CABRA DEVELOPMENT – SINTON ROAD AND CLARKS LANE, HOBSONVILLE AND 90 TRIG ROAD, WHENUAPAI

FAST-TRACK APPLICATION MEMORANDUM

Further to your instruction, we are pleased to provide this memorandum outlining our initial review comments for the proposed residential and industrial developments in Hobsonville and Whenuapai.

Figure 1: Proposed Residential Development

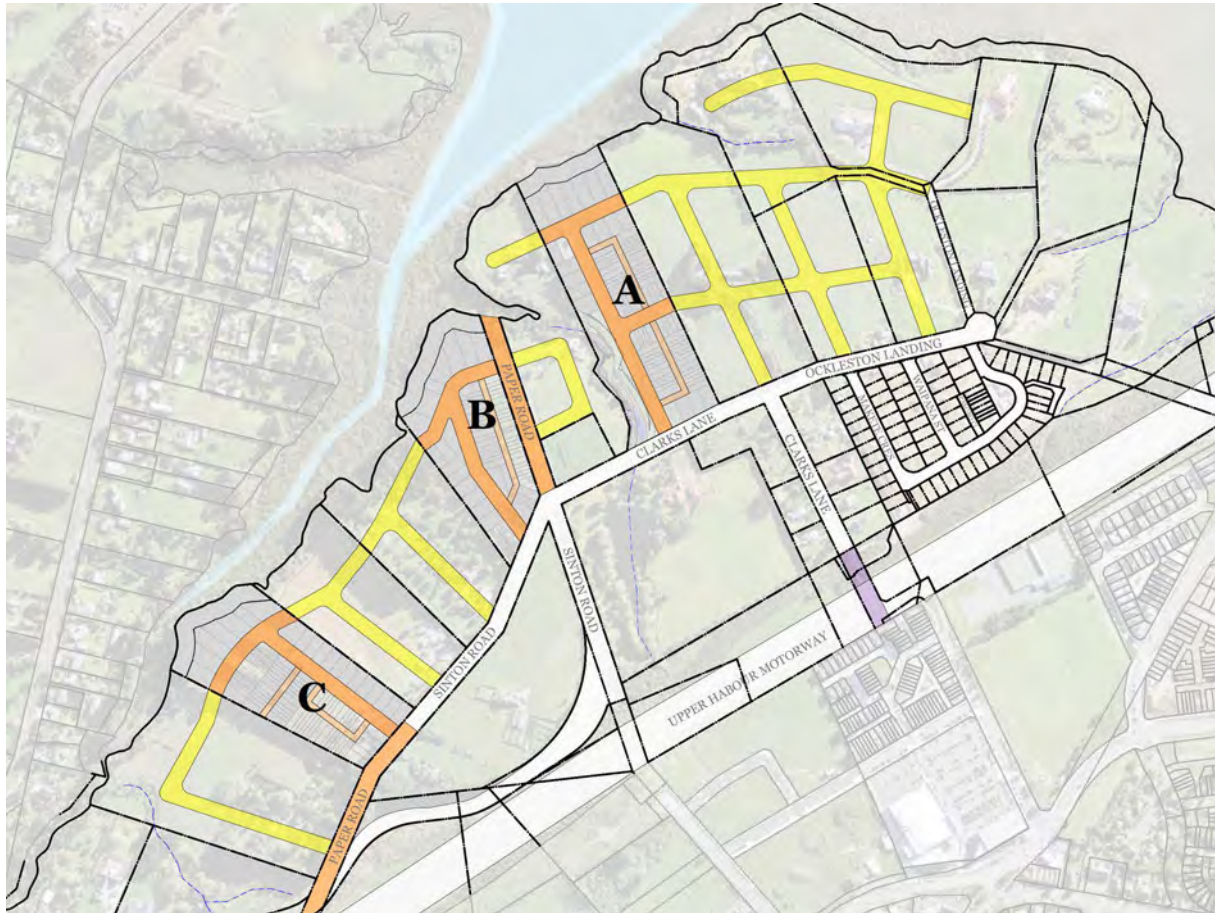
All dwellings will gain vehicle access via public roads or Joint Owned Access Lanes (JOALs). Figure 1 shows the proposed layout (internal site roads and paper roads are shown in orange, and indicative connecting roads through neighbouring sites are shown in yellow).

Due to the length, and number of dwellings, on some of the JOALs, private rubbish collection is likely to be adopted. Where possible, JOALs have been designed to have two vehicle accesses to enable service trucks to travel along the JOAL in one direction and avoid the need for complex turning manoeuvres. There is a 'dead end' JOAL in Site C and a turning head will be required to enable rubbish trucks to visit the site and enter and exit the site in a forward direction. On other JOALs, there are 90 degree bends which will need to be checked for vehicle tracking at subsequent design stages. This may require truncating some of the lots on the inside of the bends to accommodate appropriate swept paths.

As noted, all lots will gain vehicle access via public roads (Sinton Road or Clarks Lane) or Joint Owned Access Lanes (JOALs). Direct vehicle access to Sinton Road and Clarks Lane has been minimised with the majority of lots gaining access via internal local roads and JOALs. Vehicle crossings will be designed to avoid being located within 10 m of intersections and provide appropriate crossing separation distances (minimum 2 m required).

It is our experience that Council will be supportive of JOALs with up to 10 dwellings, however will likely seek public roads for greater than 10 dwellings. It is our opinion that JOALs can serve greater than 10 dwellings but it is important to ensure low vehicle speeds are achieved, a separate pedestrian path is provided and the JOAL can accommodate private rubbish collection.

The gradients of the JOALs are likely to be in the order of 5-10% and will be determined at subsequent design stages. Given parking pads are likely to front the JOALs, and those parking pads are subject to 5% maximum gradients, the JOALs are likely to have 5% grades in front of parking pads with steeper intermediate sections in between.

The public road connections to Sinton Road and Clarks Lane have been reviewed. We have visited the site to check the acceptability of the proposed intersections with respect to visibility along Sinton Road and Clarks Lane and confirm these positions are acceptable and enable relevant sight distance provisions² to be met.

Site B and Site C are located adjacent to paper roads. Site B has a paper road running alongside the eastern boundary and it is our preference to construct a road along that alignment for access to Site B. This however is proposed to be confirmed with AT at subsequent stages. In the meantime, the plan shows a proposed internal road some 25 m southwest of the Sinton Road/ Clarks Lane intersection.

Site C will require an extension to Sinton Road in front of the site (it currently terminates in a dead end near the eastern boundary of the site). The existing road will need to be extended by some 60 m to enable an intersection to be constructed with the new internal road within Site C.

Figure 4: Proposed Industrial Development

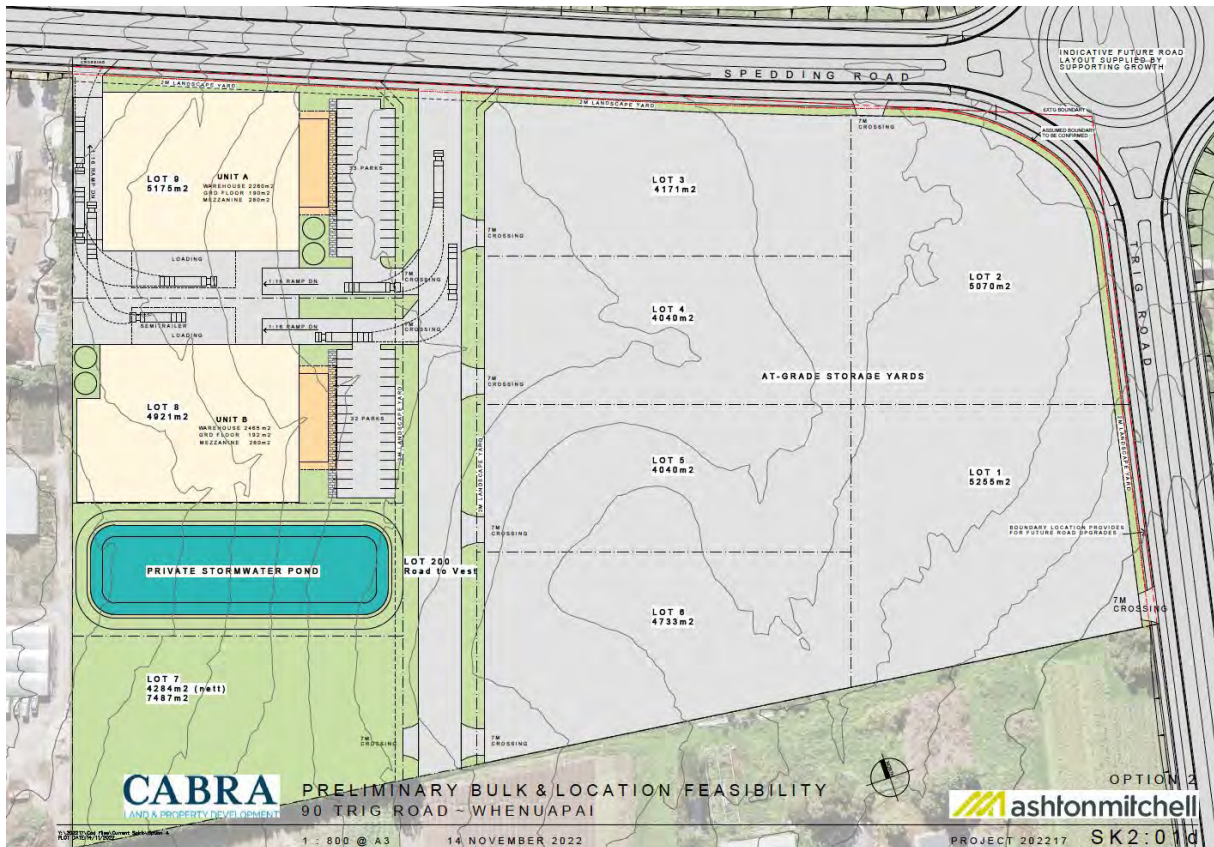
The majority of lots (Lots 3 to 9) gain access via a new local road connecting to Spedding Road, while the remaining lots have direct access to either Spedding Road (Lot 1) and Trig Road (Lot 2).

It should be noted that the concept design has made allowance for the future Trig Road/ Spedding Road designation planned by Te Tupu Ngātahi (due for lodgement later this year).

We typically expect industrial developments to generate, on average, 20 trips per ha (net development area) in the morning and evening commuter peak hours. Given the proposed access locations, we estimate that Lot 2 will generate 11 vehicles per hour (vph) directly onto Trig Road, and the remaining development (Lot 1, and Lots 3-9) will generate 73 vph directly onto Spedding Road.

As noted, Lots 3-9 are proposed to be served by a new industrial road connecting to Spedding Road. The road is proposed to be 20 m wide with a 12 m wide carriageway. This is considered appropriate to accommodate heavy vehicles. Lots 1 and 2 will have vehicle crossings connecting directly to Trig Road and Spedding Road respectively. We will undertake vehicle tracking to confirm the required width of vehicle crossings but due to swept path requirements of heavy vehicles, these crossings are likely to exceed Unitary Plan maximum widths.

As noted, the majority of lots will gain vehicle access via a new industrial road. Direct vehicle access to Trig Road and Spedding Road has been minimised with only Lots 1 and 2 gaining access this way. Vehicle crossings have been located at least 10 m from existing and future intersections and provide appropriate crossing separation distances (minimum 2 m required).

The industrial road connection to Spedding Road, and the direct vehicle crossing connections to Trig Road (Lot 1) and Spedding Road (Lot 2) have been reviewed. We have visited the site to check the acceptability of the proposed intersections, and crossings, with respect to visibility along Trig Road and Spedding Road and confirm these positions are acceptable, and enable relevant sight distance provisions⁶ to be met.
